PLANS OF PROPOSED IMPROVEMENT ON THE
PRIMARY ROAD SYSTEM
OSCEOLA COUNTY
Bridge Replacement
IA 9 OVER POLLY CREEK, 0.9 MI W OF IA 60

D2 PLAN - Date: 08-29-2025

FINAL PROJECT CONCEPT STATEMENT
IA 9 Bridge over Polly Creek, 0.9 mi W of IA 60

FIELD EXAM QUESTIONS

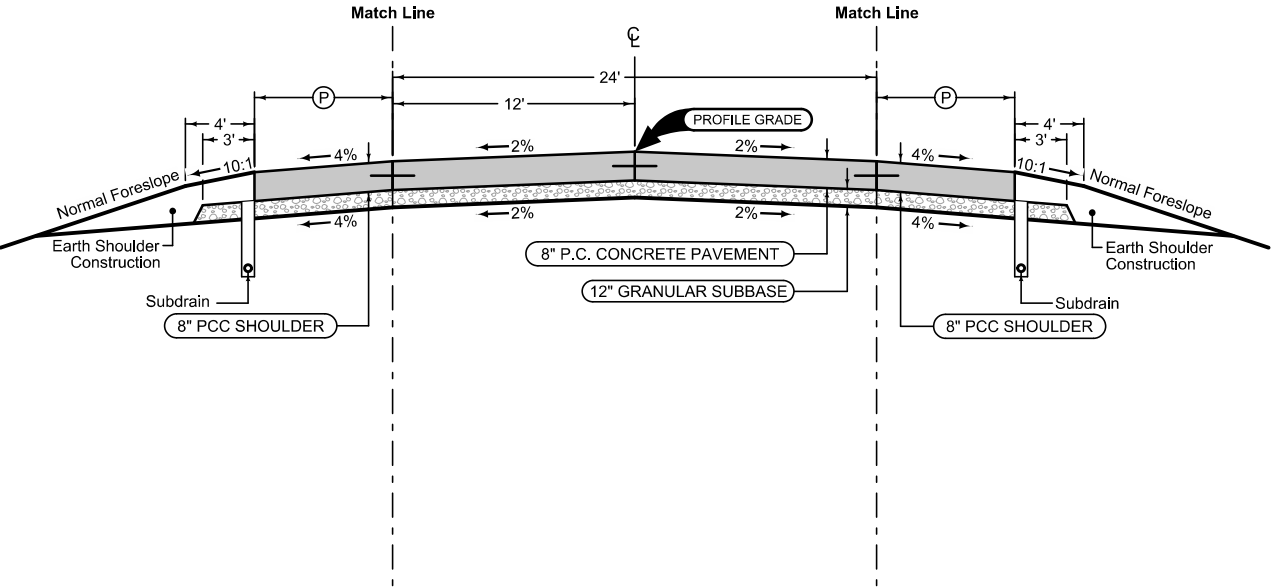
The speed limit on IA 9 is 55 mph and we are using a 60 mph Design Speed. If we can get an exception to reduce the design speed to 55 mph, this would reduce the earthwork as well as construction limits.

Power poles will be located within ditch area. Discuss utility relocation.

The DGN file in the DistrictROW ProjectWise folder does not contain any ROW lines. Is this information available?

In order to tie the existing ditches into the proposed culvert inverts, the proposed ditch grades exceed the 3% desirable grade. Should we consider extending the proposed ditch beyond the roadway limits to allow for flatter proposed ditch grades?
